1997 - 1999 Corvette: Service Bulletin: Loose or Missing Headlamp Door Bezel Plug

Subject: Loose or Missing Headlamp Door Bezel Plug (Install New Bezels and Plugs)
Source: Chevrolet Dealer Technical Service Bulletin
Number: 99-08-42-005
Models: 1997-99 Chevrolet Corvette

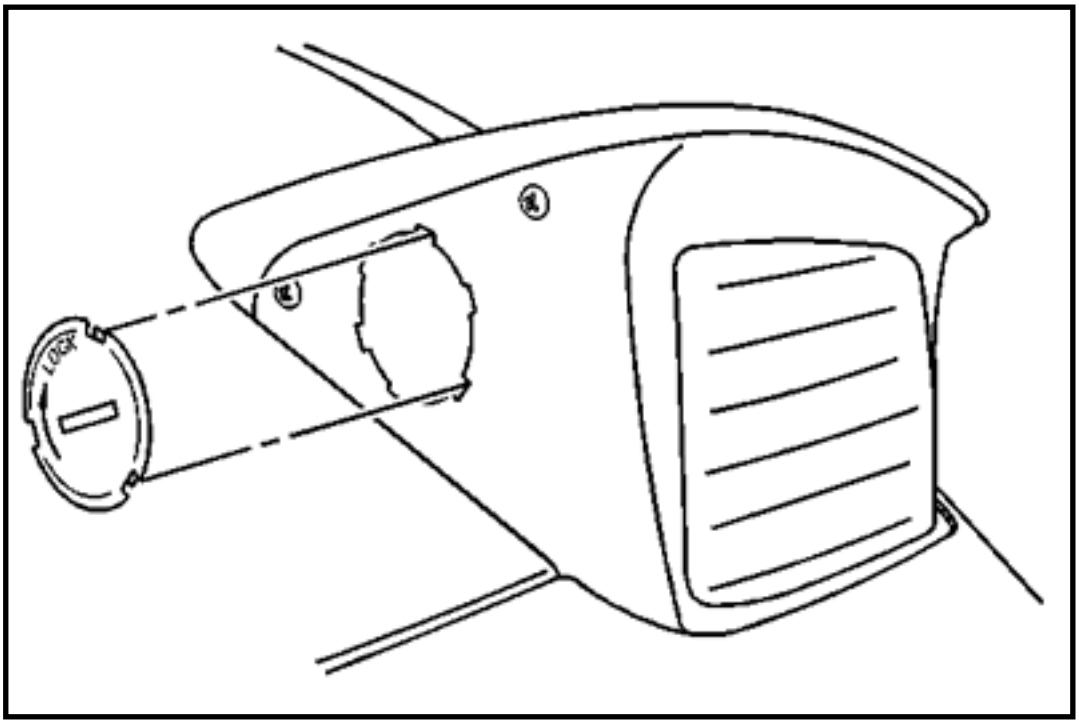
Some customers may comment that the plastic plug that covers the headlamp aiming adjustment screw on the inboard side of the headlamp door bezel is loose or missing.

Two different size plugs have been used in production. Early production 1997 vehicles used a plug with a diameter of 24 mm (15/16 in), while later 1997 vehicles and all 1998 and 1999 vehicles use a larger 54 mm (2 1/8 in) diameter plug. Both size plugs have been replaced by a new design plug and, therefore, will no longer be available.

Using the following service procedure, replace both the left and right headlamp bezels with the new design bezels that have a large NOTCHED hole. The notched hole is required for installing a new design NOTCHED plug.

1. Open the engine compartment hood.
2. Turn the headlamp switch to the ON position (the headlamp doors will open and the lamps will illuminate).
3. Turn the headlamp switch back to the PARK lamp setting (headlamp doors will remain open).
4. Remove and discard both the left and the right headlamp bezels and plugs, following the information in the Body & Accessories section of the appropriate Service Manual.
5. Install the new left and right headlamp bezels.
6. Align the notches on the new plug with the notches in the opening in the new headlamp bezel.
7. Using a quarter or a flat-bladed screwdriver, slowly rotate the plug in

the direction shown by the arrow on the outside of the plug until a click can be heard or felt.
